# Procurement of Plant Design, Supply, Delivery, Installation, Testing and Commissioning of Lot 1: 400 kV Ratmate Substation and works at Lapsiphedi and New Hetauda Substations Lot 2: 400 kV New Butwal Substation Lot 3: 400 kV New Damauli Substation

# MCA-N/ETP/CB/004

# ADDENDUM #7

# Issued on: 17 August 2023

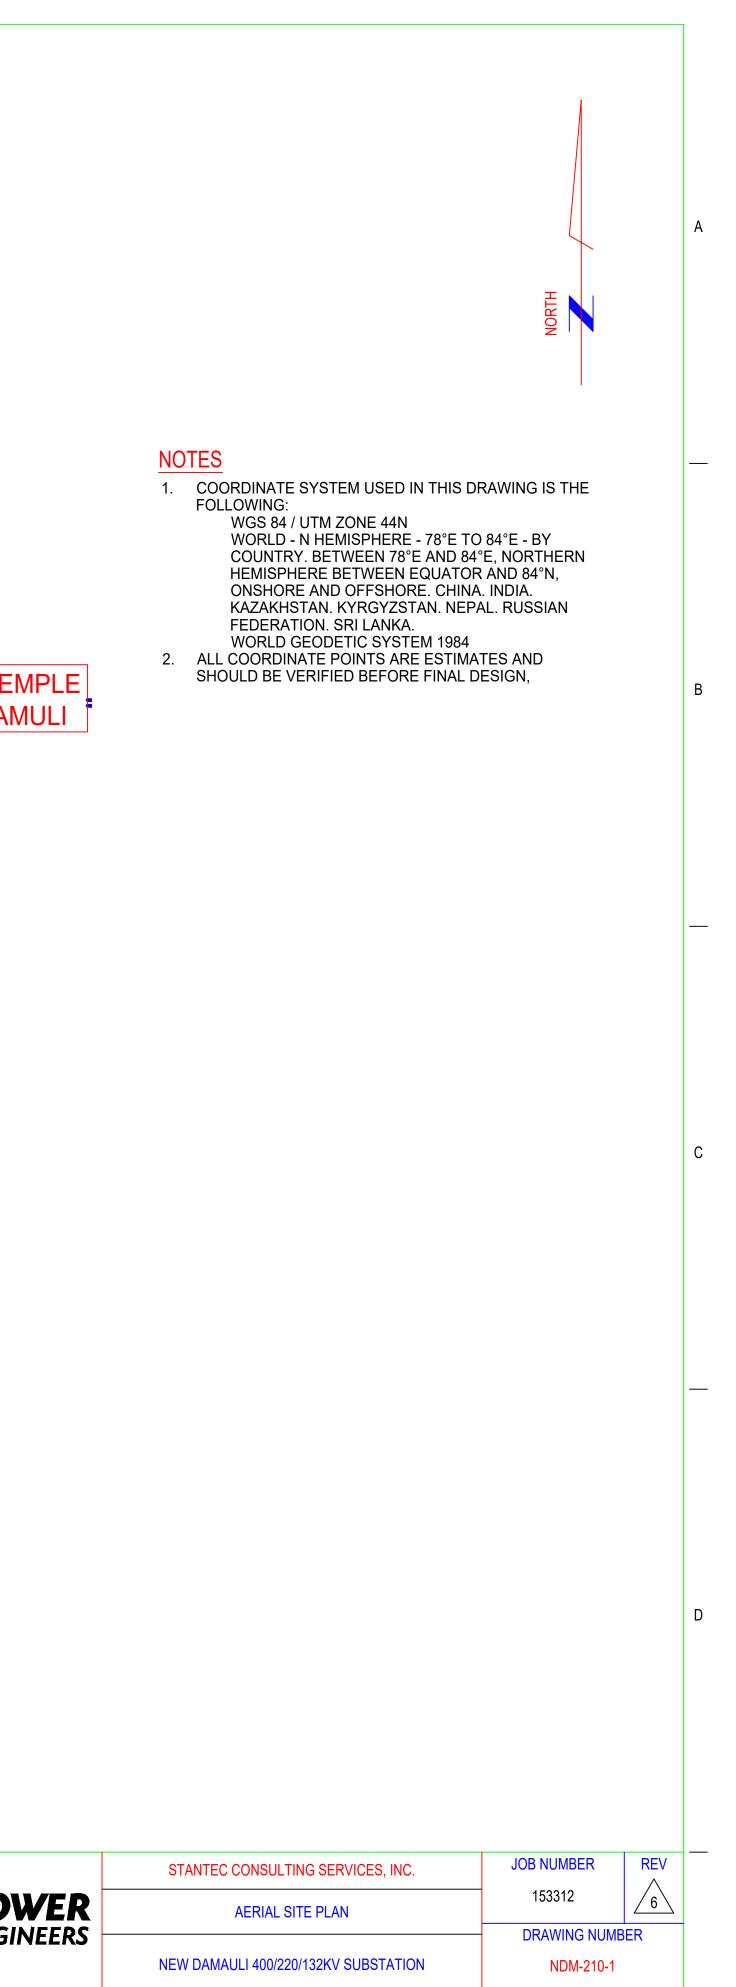
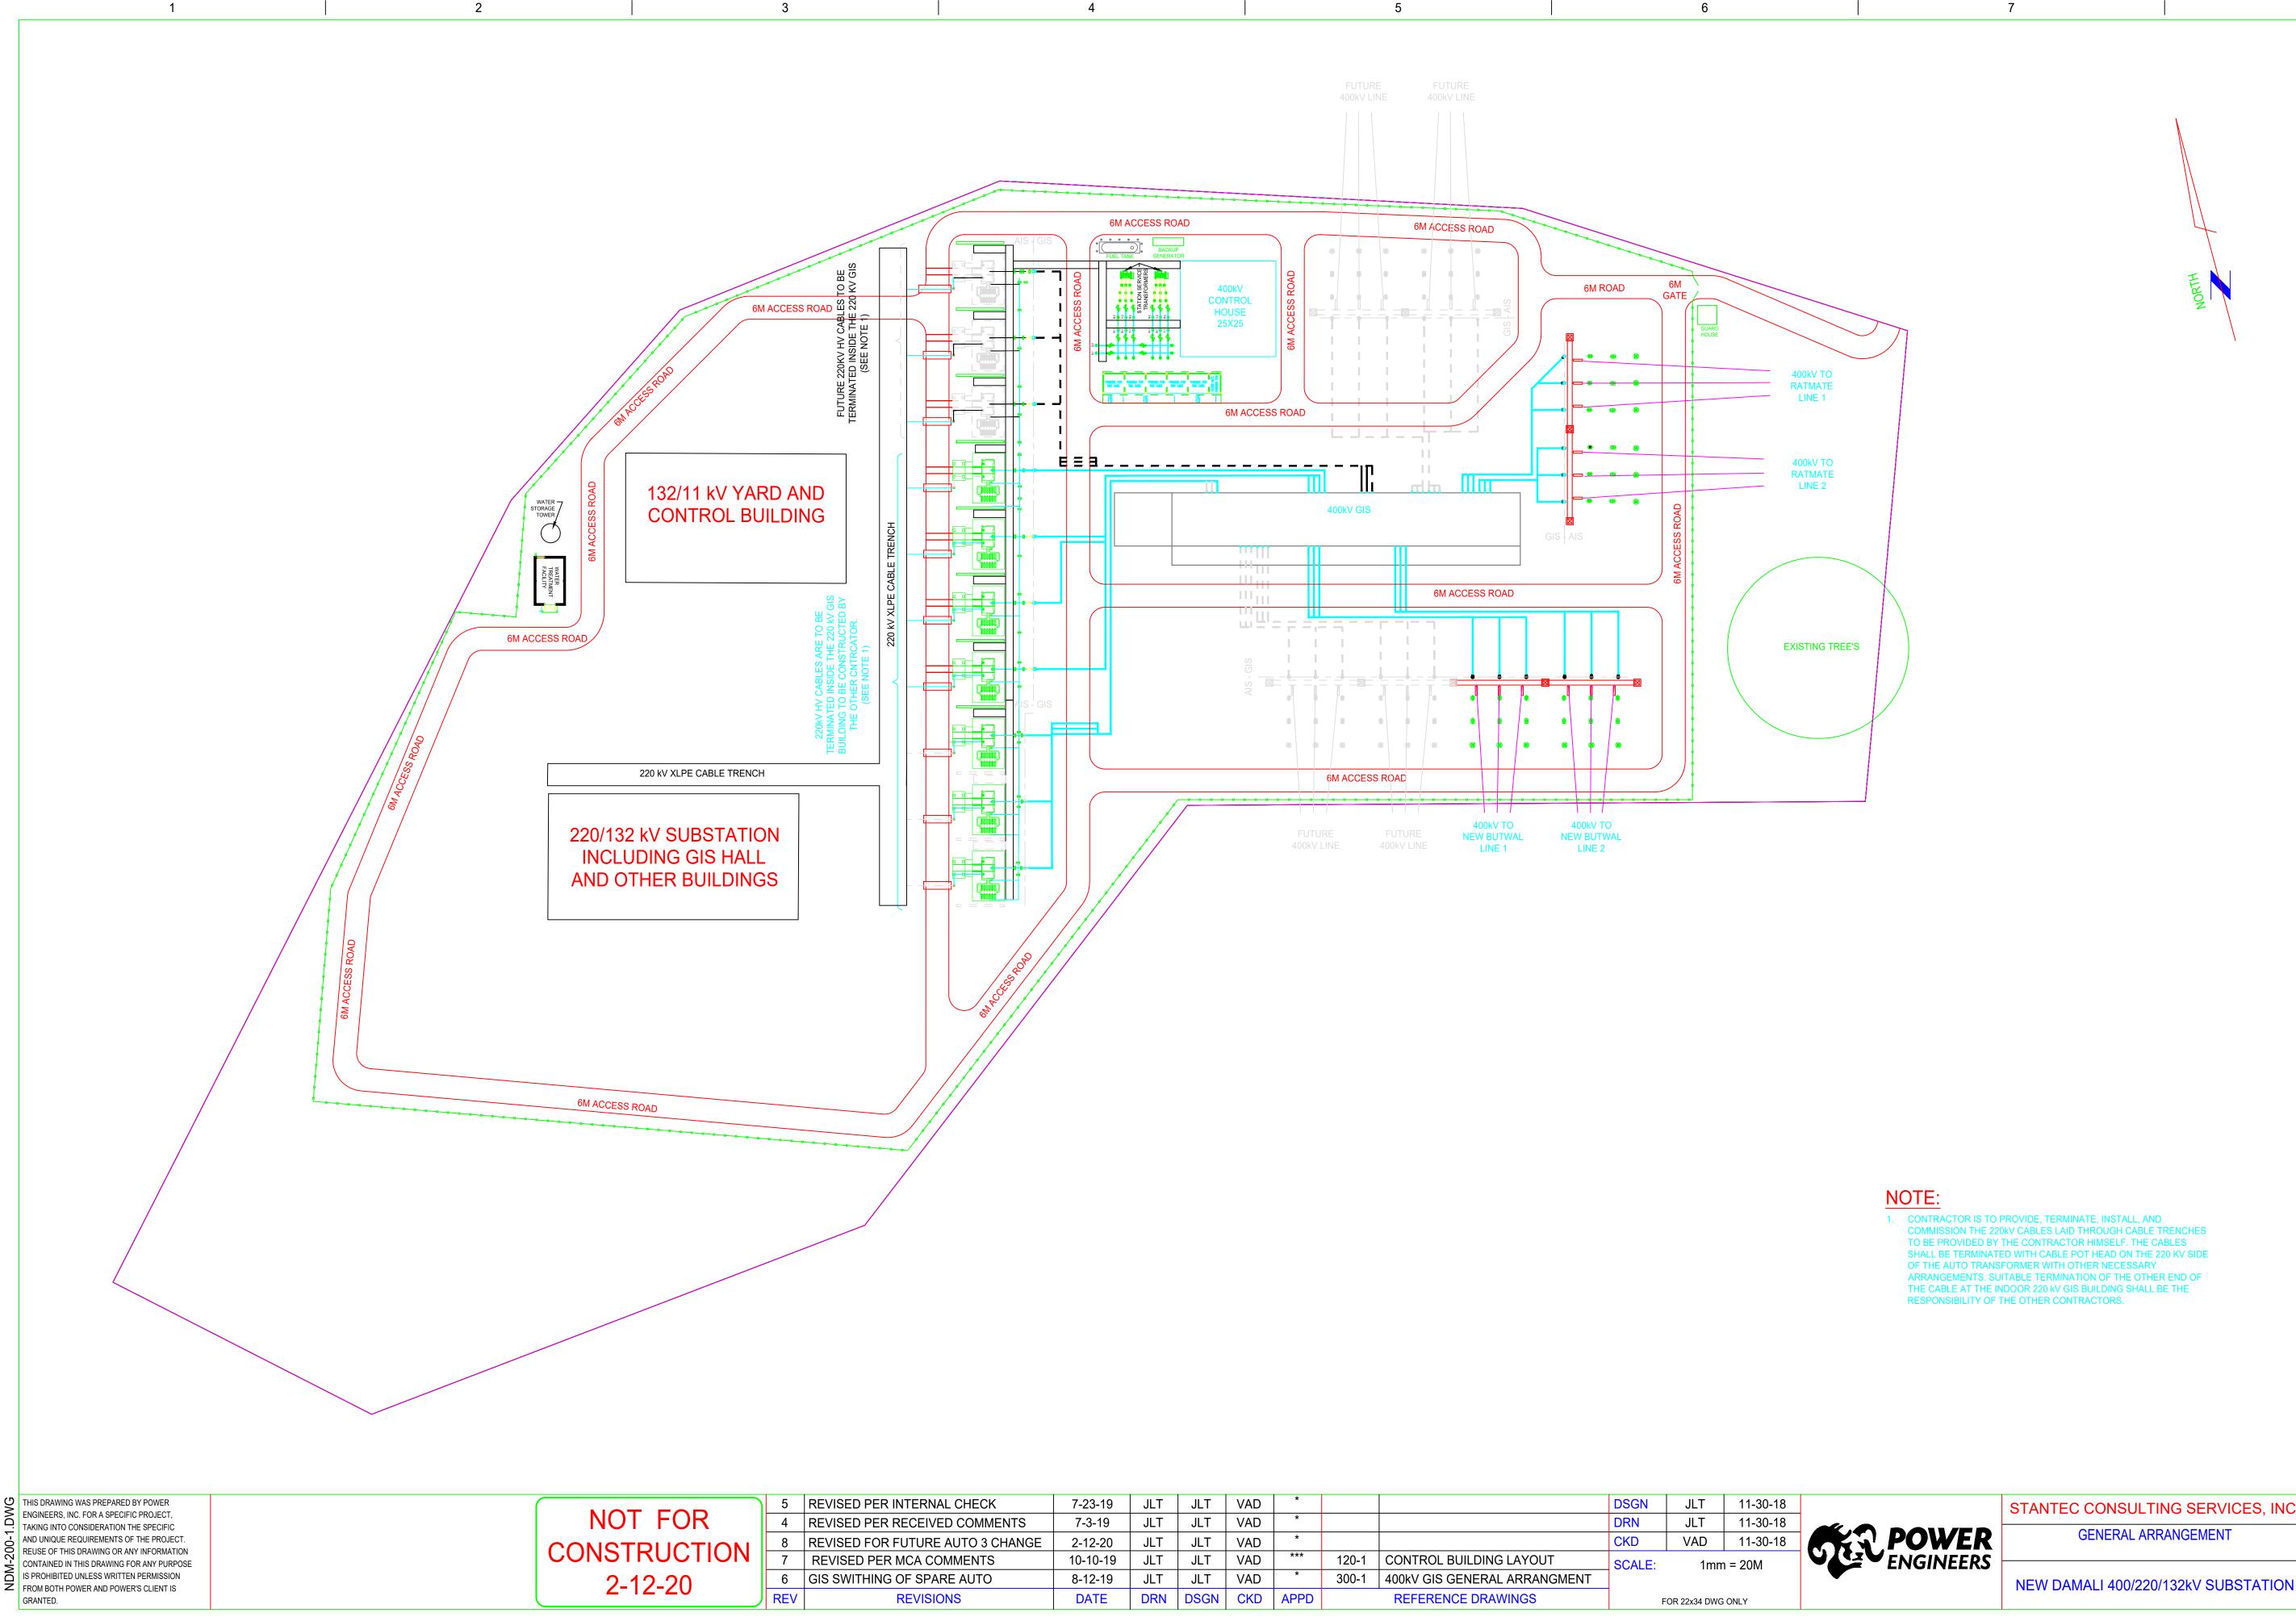
SN	Pages/Paragraph	Amendments
6.	Part 2, Section V, B11_PSR, Lot3_NDM_DWG, B1.1, Project Specific Requirements (PSR), System_DWG,	NDM-200-1-Rev 7 NDM-210-1-Rev 5 has been replaced by: NDM-200-1-Rev 8 NDM-210-1-Rev 6 The files are included as Attachment#3 to this addendum.

1. CONTRACTOR IS TO PROVIDE, TERMINATE, INSTALL, AND COMMISSION THE 220kV CABLES LAID THROUGH CABLE TRENCHES TO BE PROVIDED BY THE CONTRACTOR HIMSELF. THE CABLES SHALL BE TERMINATED WITH CABLE POT HEAD ON THE 220 KV SIDE OF THE AUTO TRANSFORMER WITH OTHER NECESSARY ARRANGEMENTS. SUITABLE TERMINATION OF THE OTHER END OF THE CABLE AT THE INDOOR 220 kV GIS BUILDING SHALL BE THE RESPONSIBILITY OF THE OTHER CONTRACTORS.
